Applicable Urban Design Priorities Project Should Achieve

The Trinity Strand Trail Bridge and Extension is a 0.4 mile long extension of the existing Trinity Strand Trail on the northern banks of the former Trinity River riverbed in the Design District. The proposed project will construct a bridge across the existing waterway at the end of Hi Line Drive, providing a more direct connection from existing uses on the east side, including the Virgin Hotel, to uses on the west side, including the Rodeo Goat restaurant. The project will also construct a trail along the northern side of the sump from the bridge, west to Express Street.

Trinity Strand Trail Bridge +Extension

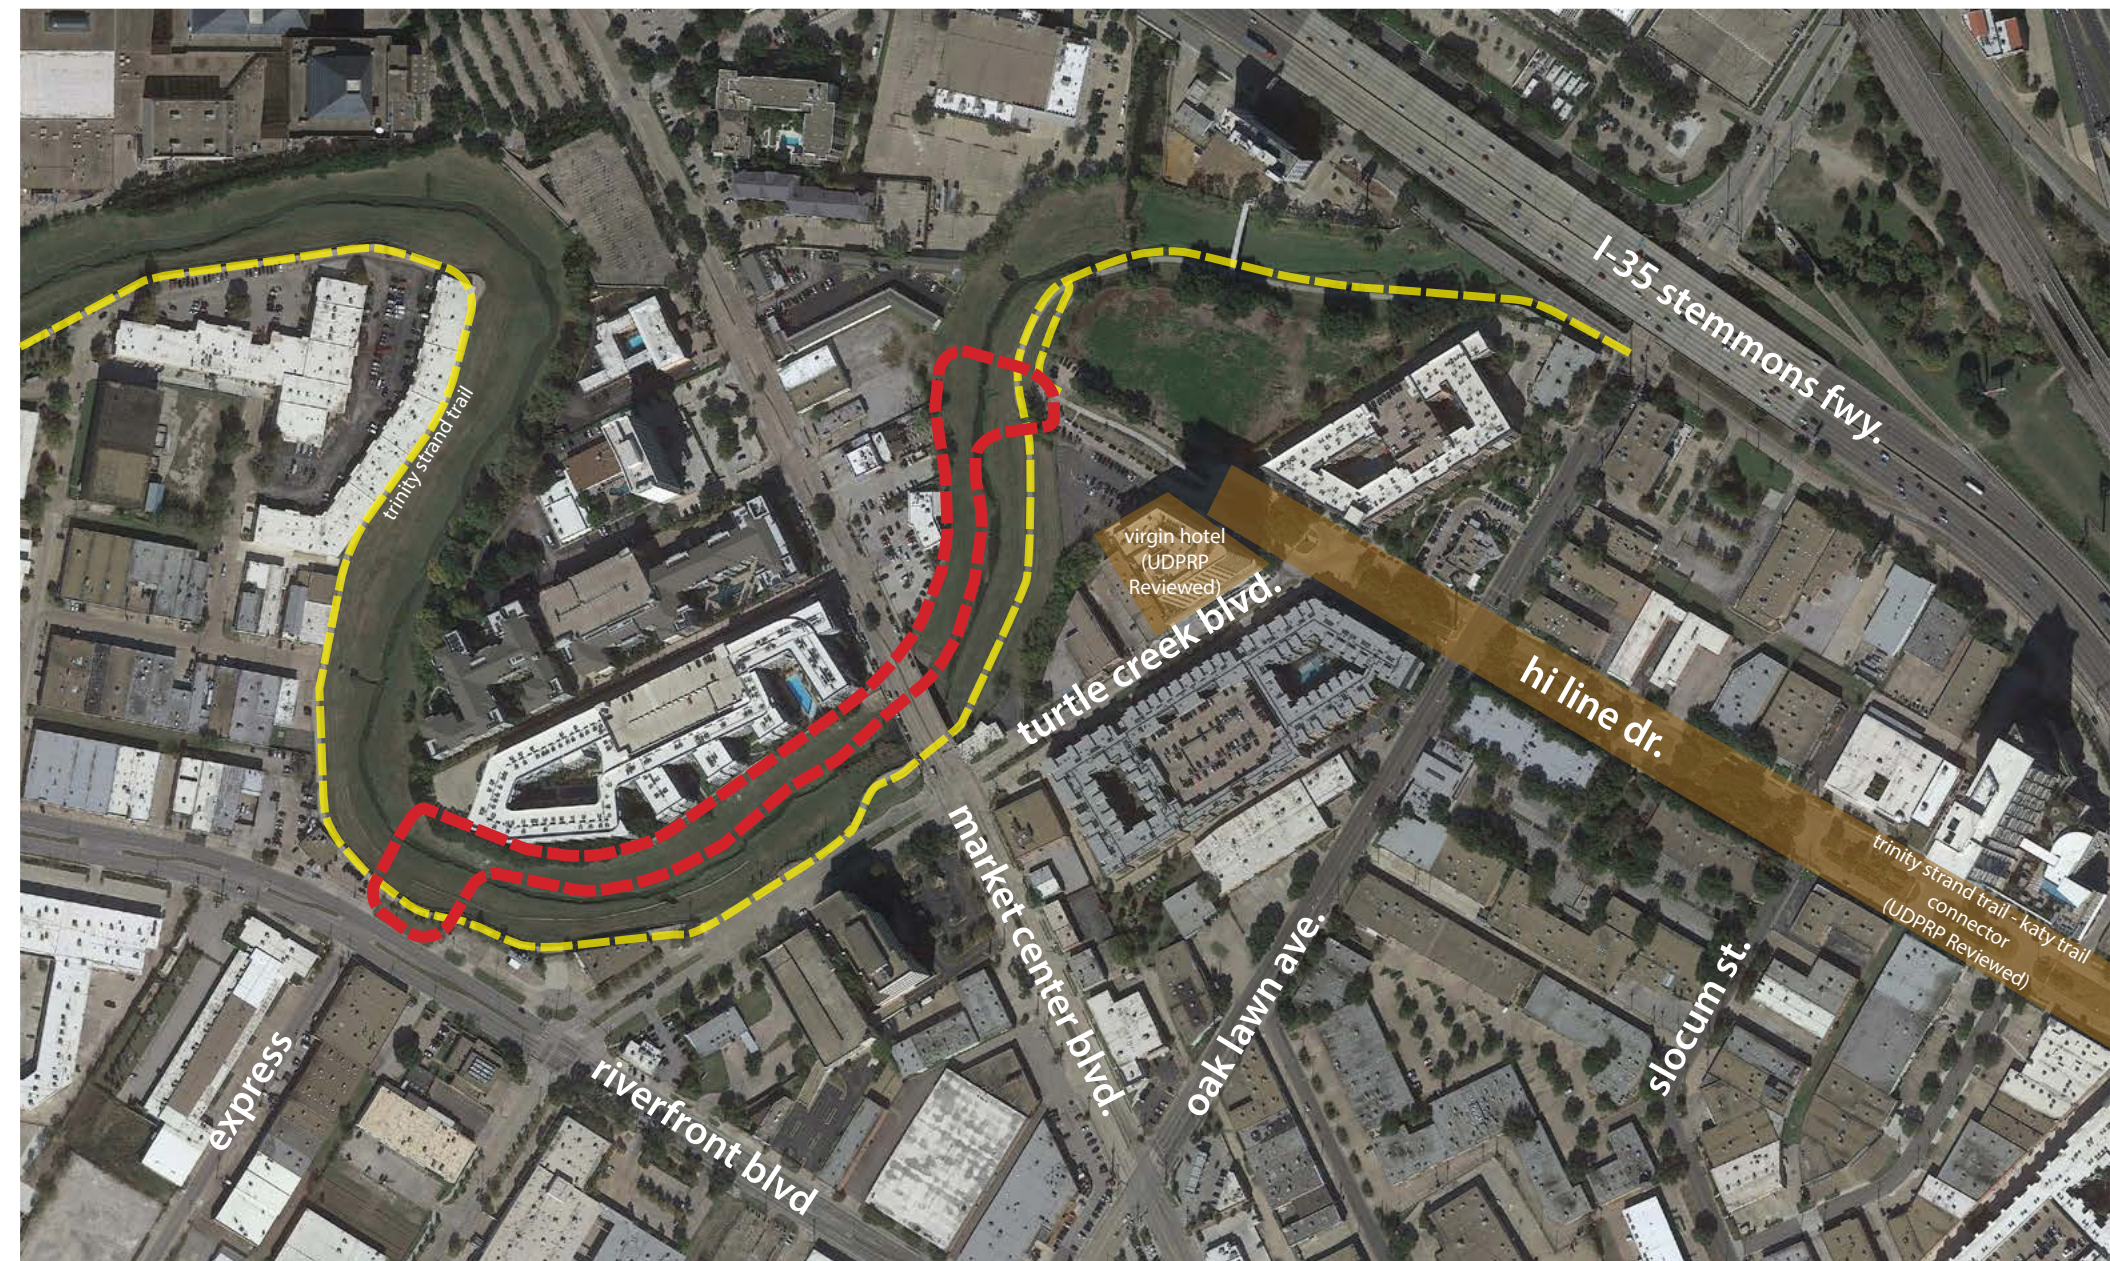
- [1] Further refine the design of gateway at the end of Hi Line Drive to create a public gathering space for the neighborhood -

The landing of the bridge at the end of Hi-Line Drive will serve as a signature moment as the terminus for Hi-Line Drive, while also serving as a critical space that will be traversed by users of the existing Trinity Strand Trail, the new extension of the Trinity Strand Trail, and users of the Katy Trail-Trinity Strand Trail Connector. This space should provide adequate shade, seating, and public art to effectively function as a point of triangulation for the district.
